To: Members of the Zoning and Platting Commission, Alison Alter, and Ashley Fisher

From: 2222 CONA

Subject: Opposition to Case SPC-2023-0357C – North Trail Office Park Development

Google maps shows how close the proposed development is to Bull Creek (it is proposed to be built at the end of the Waterloo Ice House strip center).

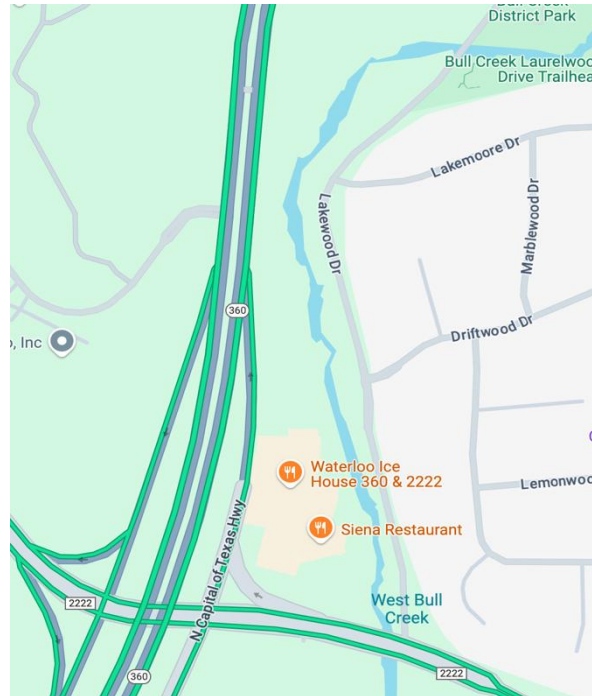
- **Proximity to Bull Creek:** The development site is directly adjacent to Bull Creek, a critical water feature and floodplain (Zone AE per FEMA). Although the plan claims no development within the floodplain, construction activities and increased impervious cover could disrupt natural water flow, increase runoff, and jeopardize the creek's ecological balance.
